South Texas Project  
Units 3 and 4  
Docket Nos. 52-012 and 52-013  
Revised Responses to Requests for Additional Information

**RAI 09.02.05-7****QUESTION:**

**RAI 14.03.05-2**

Figure 3.0-1 UHS and Reactor Service Water System  
(Single Division Shown Typical of Divisions A, B, and C)

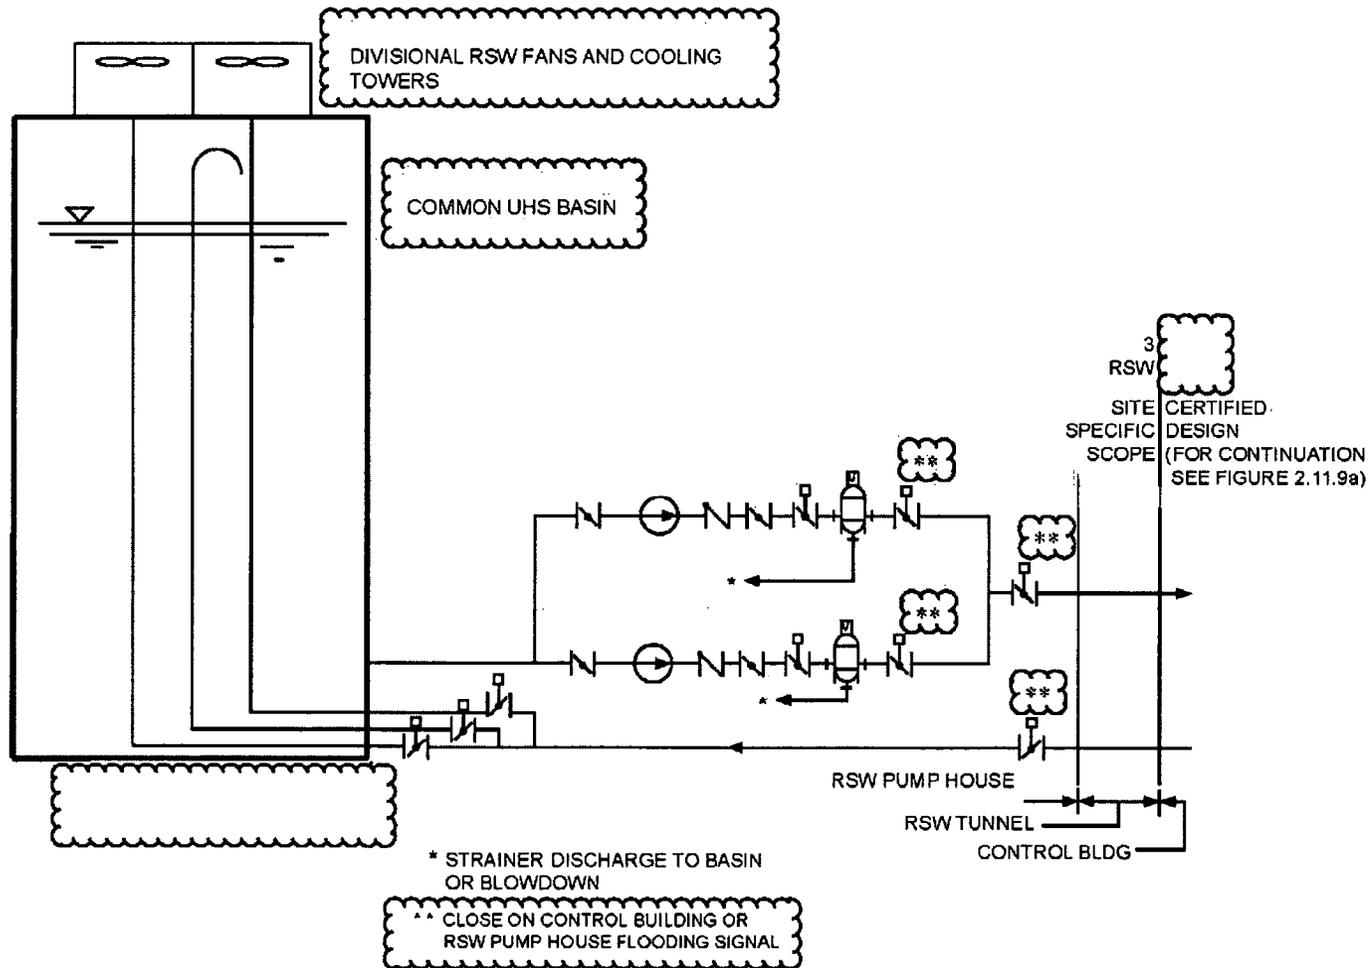
Please explain why the acceptance criterion as written does not address the ‘required functions of the UHS system’ stated in the design commitment and how the figure referenced provides sufficient information to allow the implementation of this ITAAC given that the figure lacks the required details.

Finally, NINA is providing additional details to COLA Part 9, Figure 3.0-1 which complements the changes described above. Deleted from the Figure is redundant information (3 RSW) that is correctly shown on Tier 1 Figure 2.11.9a.

As a result of this RAI response, COLA Revision 5, Part 9, Table 3.0-1 Item 4, Table 3.0-5 Items 5 and 7, and Figure 3.0-1, are revised as shown below by grey shading or bubbles:
